Engine and RJB lighting

Customer Adaptation of luggages compartment lighting

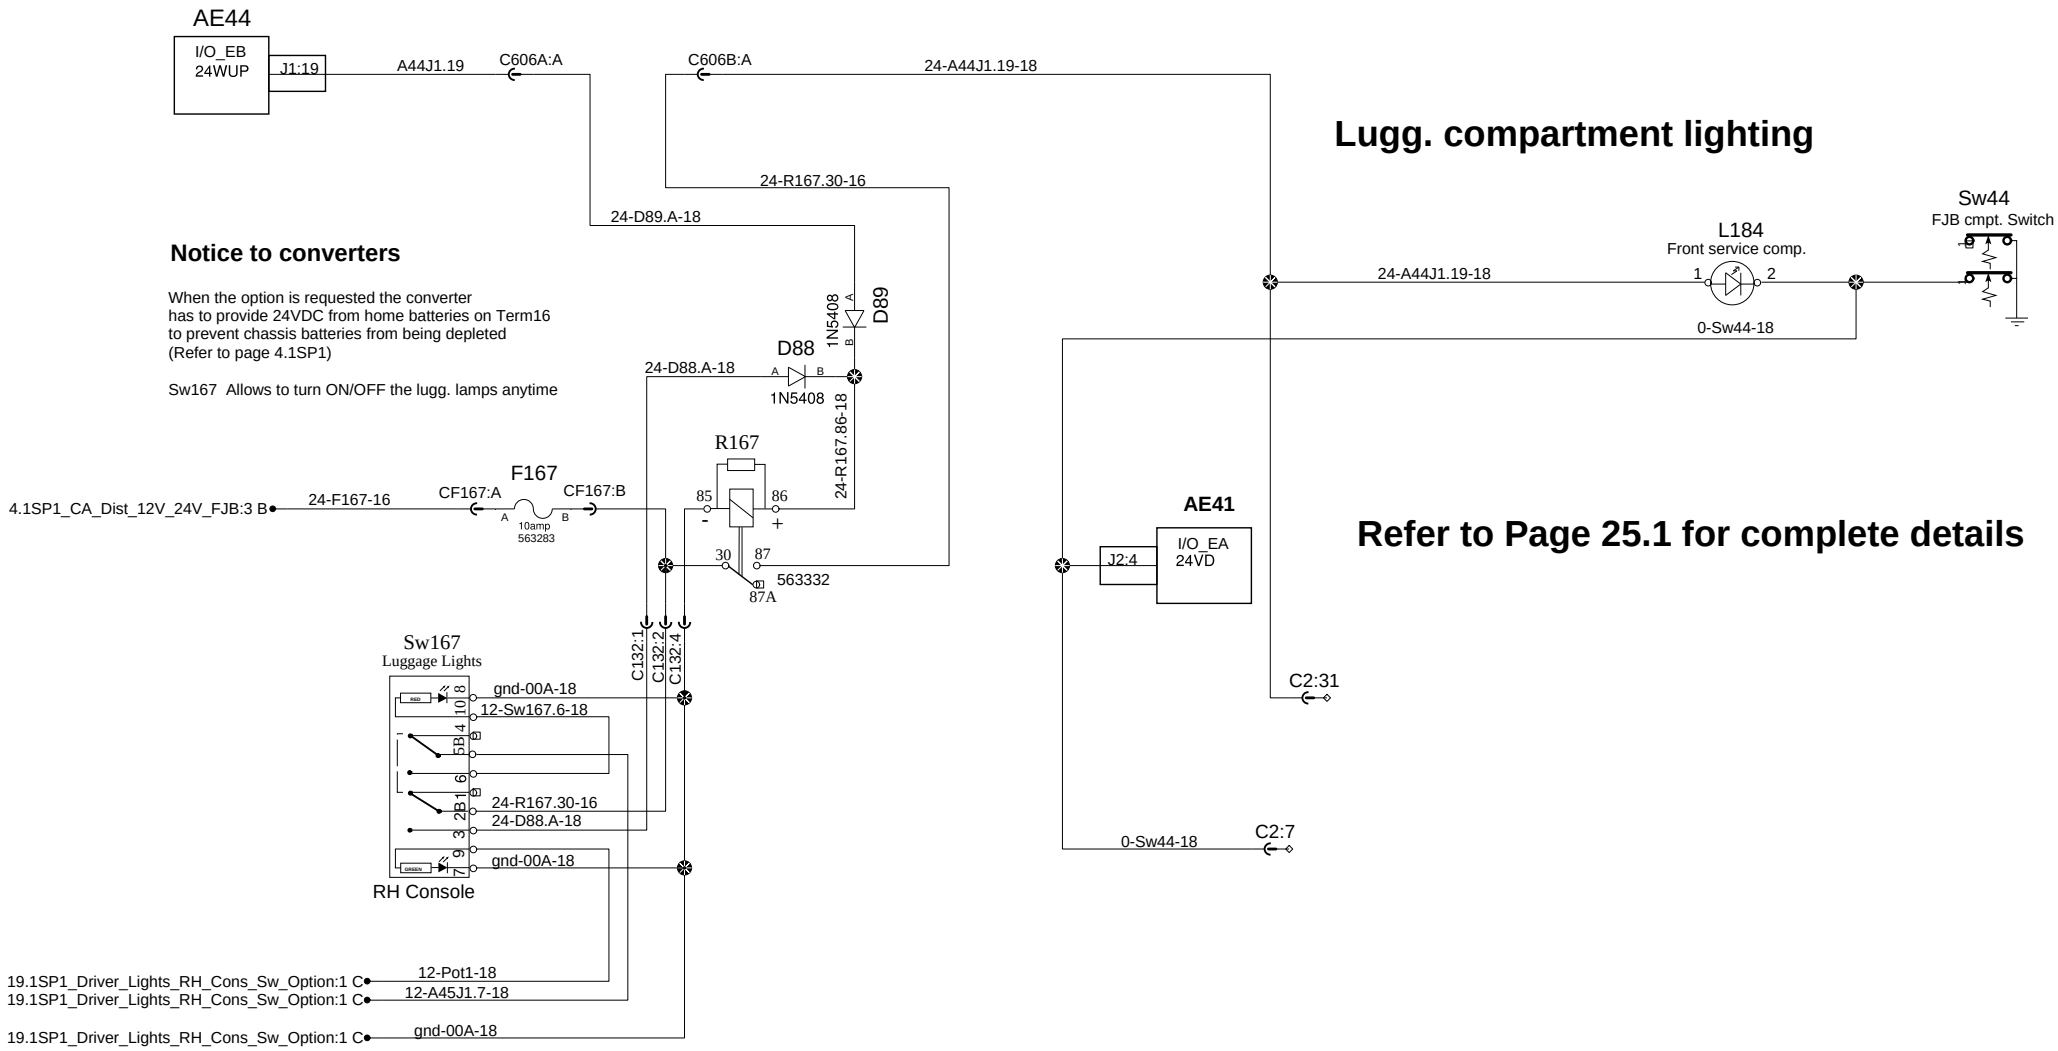
When the option is requested the converter has to provide 24VDC from home batteries on Term16 to prevent chassis batteries from being depleted (Refer to page 4.1SP1)

Sw167 Allows to turn ON/OFF the lugg. lamps anytime
